UN Regulations on Light Sources and the Consolidated Resolution on the Common Specification of Light Source Categories

Proposal for amendment 9 to the Consolidated Resolution on the common specification of light source categories (R.E.5)

Submitted by the expert from the International Automotive Lighting and Light-Signalling Expert Group (GTB)*

Figure 1*
Main Drawing

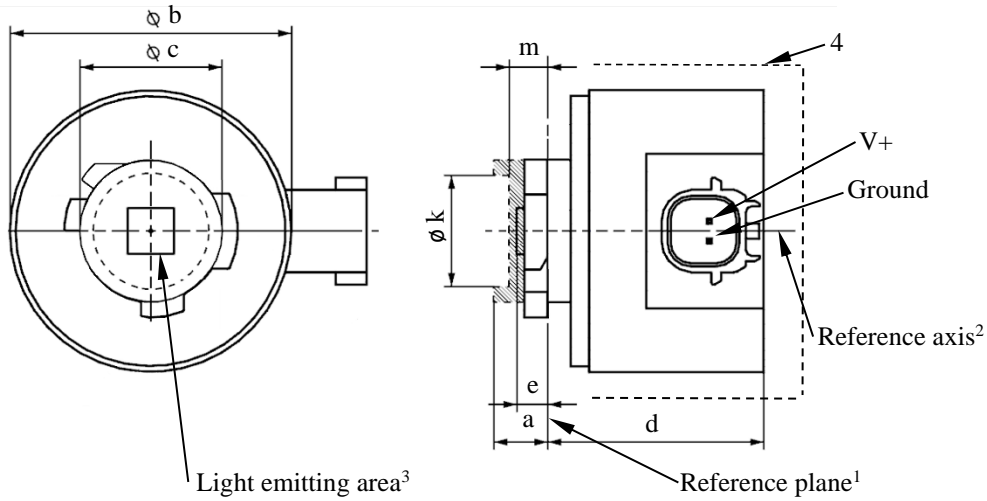
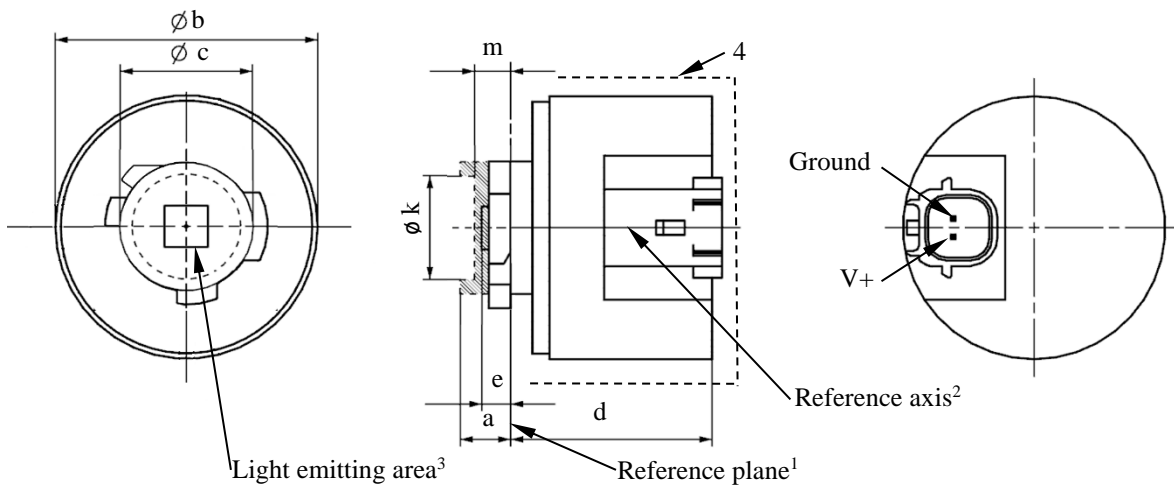
Annex 3, Sheets Lx6/1 to 6, amend to read:

^{5/} The emitted light shall be red for LR6A and LR6B, **white for LW6A and LW6B, and amber for LY6A and LY6B.**

^{10/} **Operated in flashing mode for 30 minutes (frequency = 1.5 Hz, duty cycle 50 per cent ON, 50 per cent OFF). Measured in the ON-state of flashing mode after 30 minutes of operation.**

A. Amendment to introduce new light emitting diode (LED) light source categories LW6A, LW6B, LY6A, and LY6B

2. This proposal introduces new LED light source categories for signalling to accommodate an increasing market demand for LED light sources according to UN Regulation No. 128. The ongoing trends towards style driven DRL lamps, high-performance reversing lamps, and direction indicator lamps, require light sources with higher luminous output to compensate for the lower efficiency of the corresponding optical designs.

3. In general, standardized and replaceable UN Regulation No. 128 LED light sources can serve individual signalling lamp designs with limited development efforts. The proposed categories of high luminous flux mono-function amber and white light sources are based on an established cap concept with an increased and more precise light output, while a new and future-proof specification of the light emitting area (LEA) allows a more reliable description of where the light originates from.

4. For the white light sources, the specifications for the proportion of the total luminous flux in Table 3 were established in accordance with the performance of white light generating LED technology. This means that for the same LEA definition, in some instances specifications for the white light version vary slightly from those of the monochromatic red and amber light versions.

5. The cap/holder system for the new amber and white emitting light sources is based on the IEC PGJ18.5d fit, a family of cap/holders that has already been successfully employed in existing R128 LED light sources. Keys from the PGJ18.5d fit that are not in use so far, have been assigned to the newly proposed categories. Following established LED light source categories, the new amber and white emitting light sources are proposed with an elbow connector at the side — the A version — as well as with a straight connector at the bottom — the B version. The assigned category designations for the white emitting light source are LW6A and LW6B respectively. The assigned category designations for the amber emitting light source are LY6A and LY6B respectively.

Figure 2

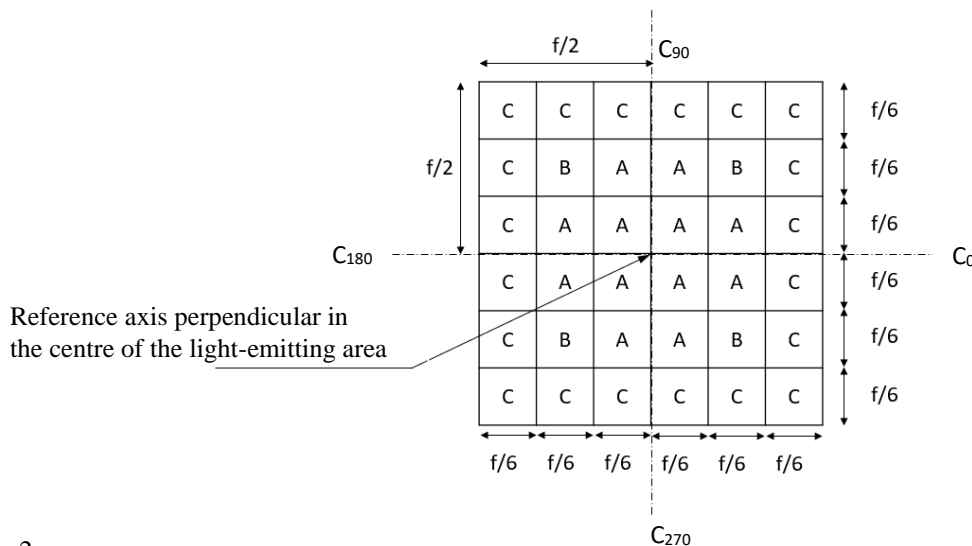
Proportion of the total luminous flux emitted into the viewing direction from the areas specified in Figure 2

<i>Category</i>	<i>Area(s)</i>	<i>LED light sources of normal production</i>	<i>Standard LED light sources</i>
LR6A, LR6B LY6A, LY6B	Each A individually	> 3% < 10 %	> 4% < 10%
	Each B individually	> 3% < 10%	> 3% < 10%
	All A and B together	> 70%	> 75%
	Each C individually	< 2%	< 2%
	All A, B and C together	> 90%	> 90%
LW6A, LW6B	Each A individually	> 3% < 10 %	> 3% < 10%
	Each B individually	> 3% < 10%	> 3% < 10%
	All A and B together	> 65%	> 70%
	Each C individually	< 3%	< 3%
	All A, B and C together	> 90%	> 90%
